## STUDIO CITY FOR QUIET SKIES

**Comment on the Neighborhood Environment Survey (Deadline April 14, 2021)**

**SUBMITTED: March 29, 2021**

# EXHIBIT 5

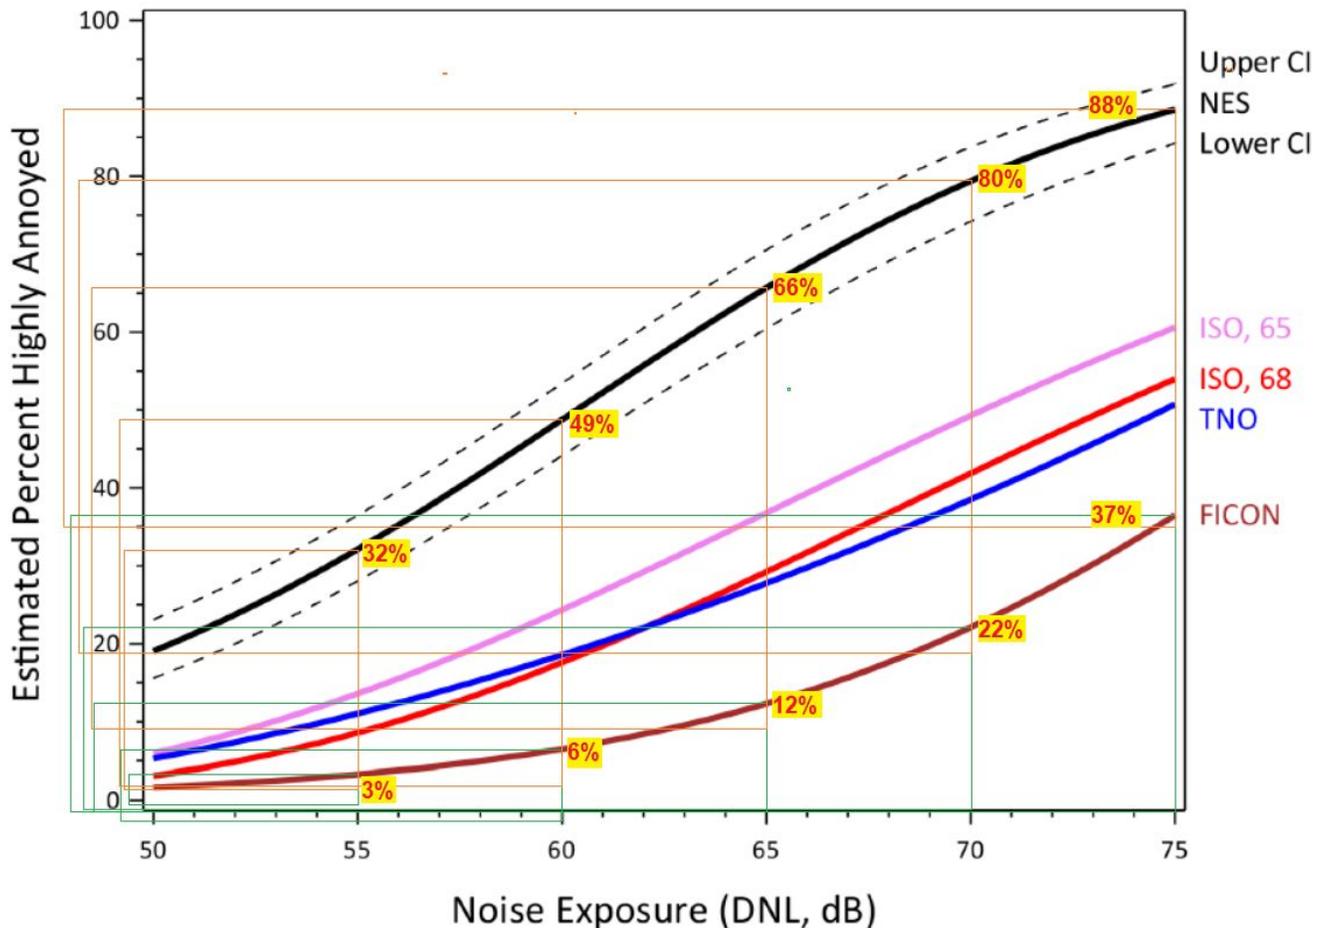
The following graphic was produced to compare ‘noise annoyance’ for the traditional FICON analysis versus the recently reported NES analysis. It is a screen-captured copy of the graph from page 53 (at PDF-page 75 of Volume 1). Thin green boxes have been added to clearly identify FICON estimates at the 55-, 60-, 65-, 70-, and 75-dB DNL exposure levels; thin orange boxes have been added to clearly identify NES estimates at the same 55-, 60-, 65-, 70-, and 75-dB DNL exposure levels.

3. NES reveals an enormously higher percent of people are ‘highly annoyed’ by aviation noise. At 55 dB DNL, the 3% highly annoyed in 1992 increased to 32% highly annoyed in 2015. At 60 dB DNL, the 6% highly annoyed in 1992 increased to 49% highly annoyed in 2015. Similarly, at 65-, 70-, and 75-dB DNL exposure levels, the estimates all increased, from 12% to 66%, from 22% to 80%, and from 37% to 88%, respectively.

4. **KEY CONCLUSIONS:** aside from how suspect the DNL metric is (so why use it as a basis for estimating citizen annoyance?), there is strong evidence that noise impacts have been severely under-reported and under-estimated. Is it time for a new metric that emphasizes impacts by repetitive and concentrated flight routes? Is it time for FAA to adopt regulatory guidelines (including flight procedures) that protect citizens from excessive aviation noise?
